## METROPOLITAN GOVERNMENT OF NASHVILLE AND DAVIDSON COUNTY

### STAFF RECOMMENDATION 1610 Forrest Avenue November 18, 2015

**Application:** New construction-infill; New construction-detached accessory dwelling unit (DADU)

Figure 2. Staff recommends adding a window in this approximate location, to help the project meet the design guidelines for openings.

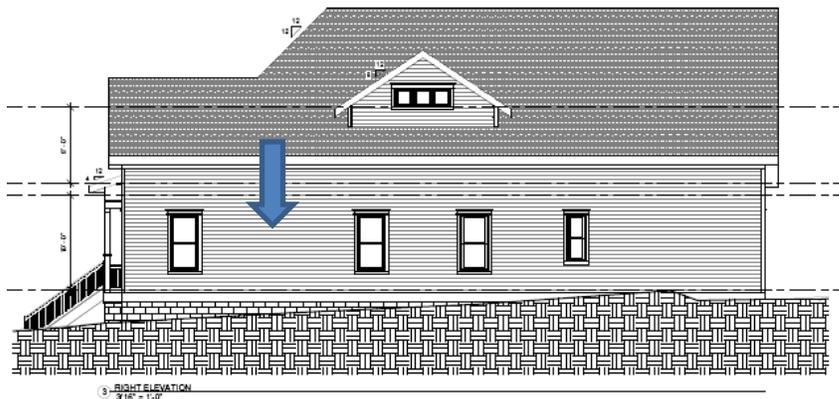
**Proportion and Rhythm of Openings:** The majority of the windows are roughly twice as tall as they are wide, meeting the historic proportions of openings. There is a long expanse of sixteen feet (16') of wall space on the right elevation without a window or door opening. Staff recommends a window opening be added in this area, to break up that expanse. With this revision, the project's proportion and rhythm of openings will meet Section II.B.7.

1. The finished floor height be consistent with the finished floor heights of the adjacent historic houses, to be verified by MHZC staff in the field;
2. A window is added to the right elevation, to break up the large expanse of wall space;
3. The applicant file a restrictive covenant for the detached accessory dwelling unit, before the permit is issued;
4. Staff approve the final details, dimensions and materials of windows and doors prior to purchase and installation and paired windows have a 4"-6" mullion between them;
5. Utilities be located at the rear of the building or on the sides beyond the midpoint of the building;
6. Staff approve the roof color and masonry color, dimensions and texture.
